Table of Contents for 2818 Rio Grande Tree Permit
Heritage Tree Variance Package

ITEM FOR ENVIRONMENTAL BOARD AGENDA

PROJECT NAME: 2818 Rio Grande

MEMORANDUM

Exhibit 5

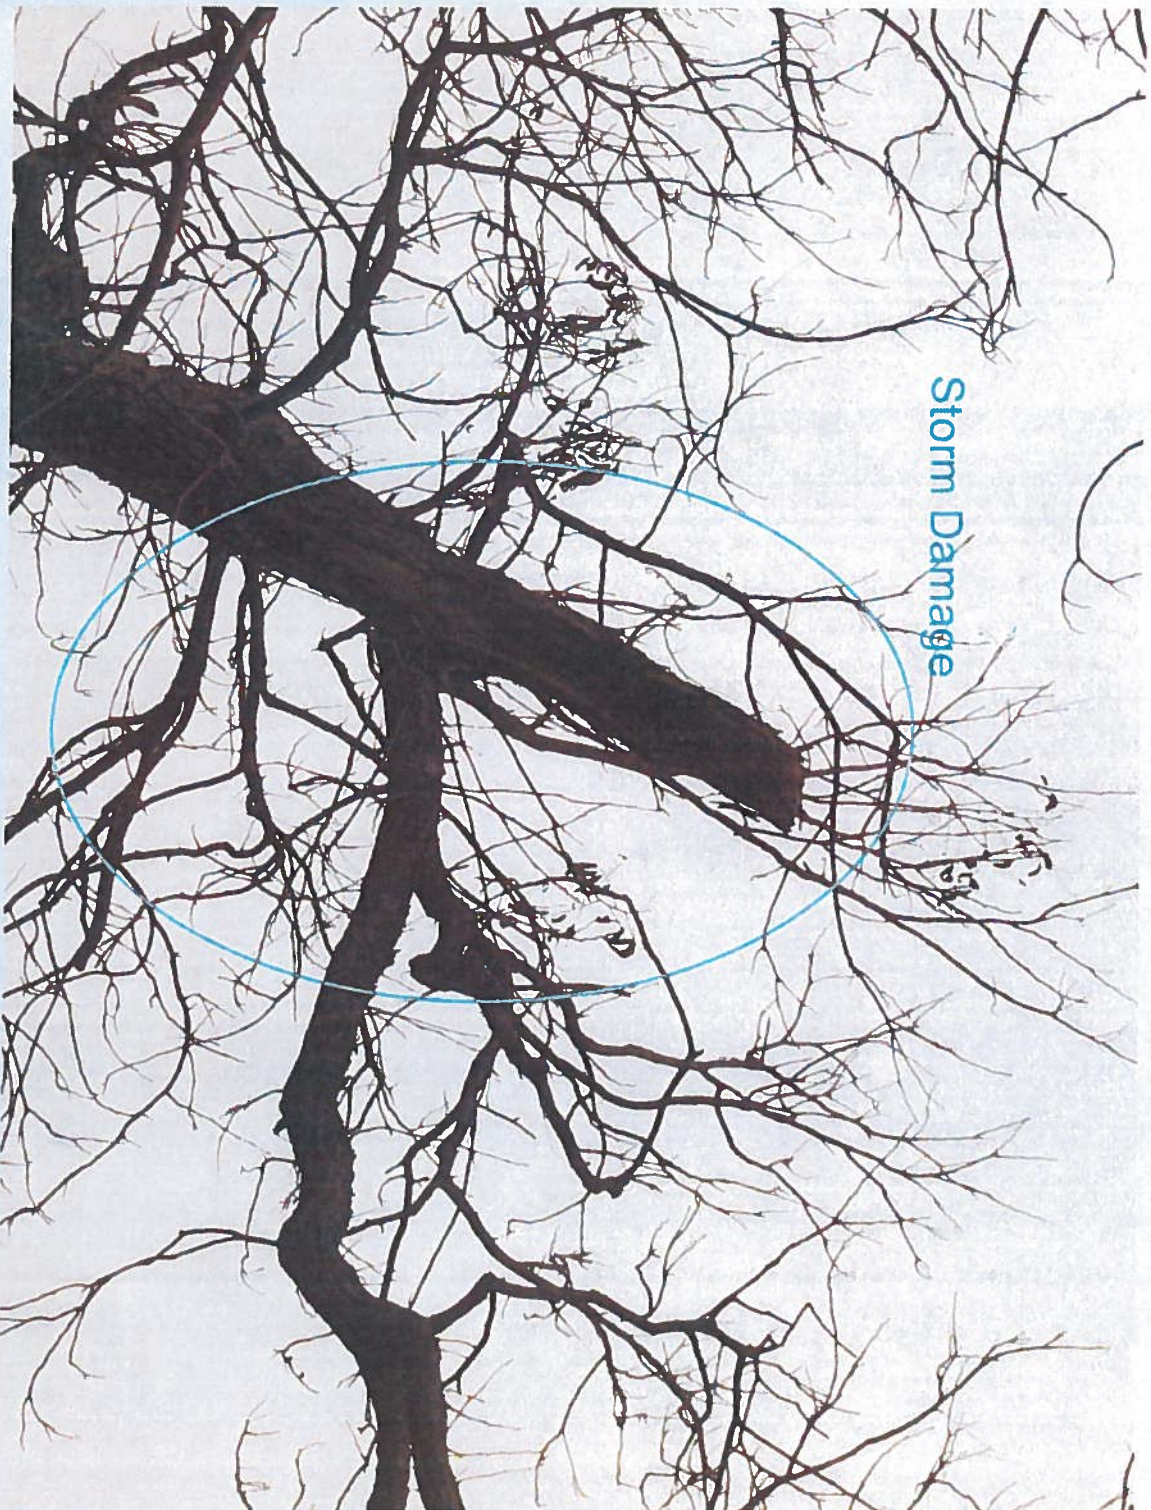
The canopy has major asymmetry, extensive storm damage, and moderate decay. Storm damage is evident by the presence of multiple broken stems and subsequent decay (Exhibits 5,6,7 and 8).

Storm
Damage

Exhibit 6

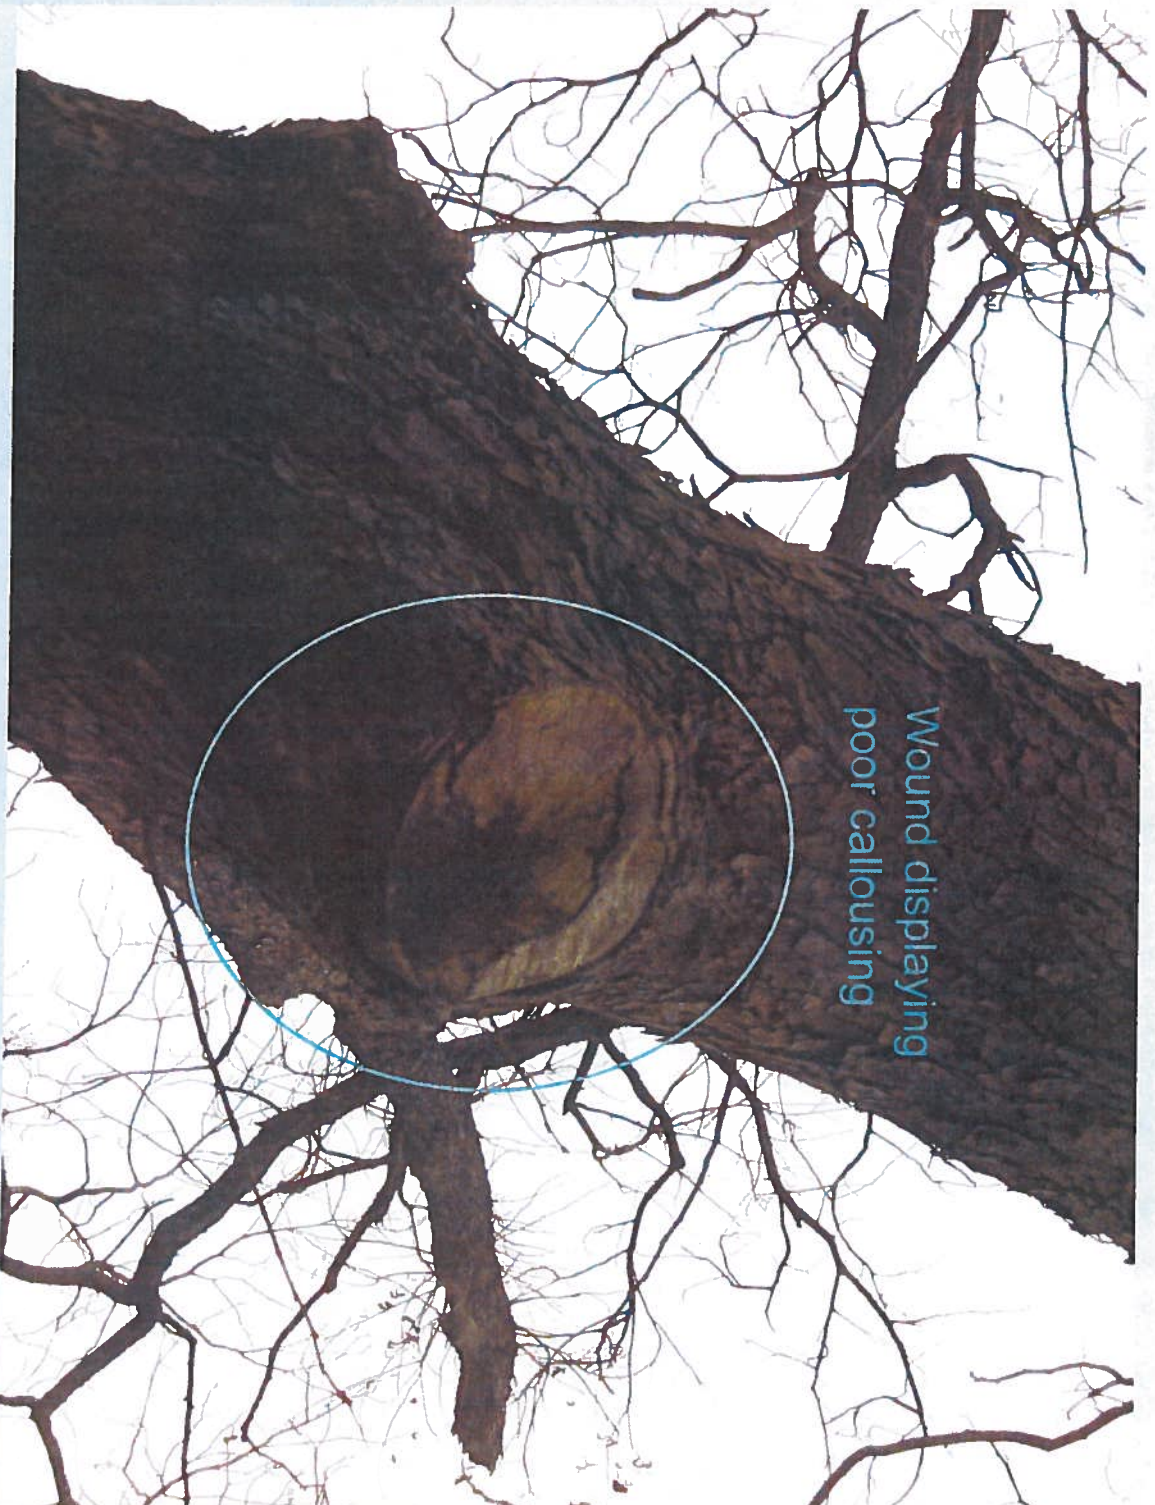
Wound displaying
poor callousing
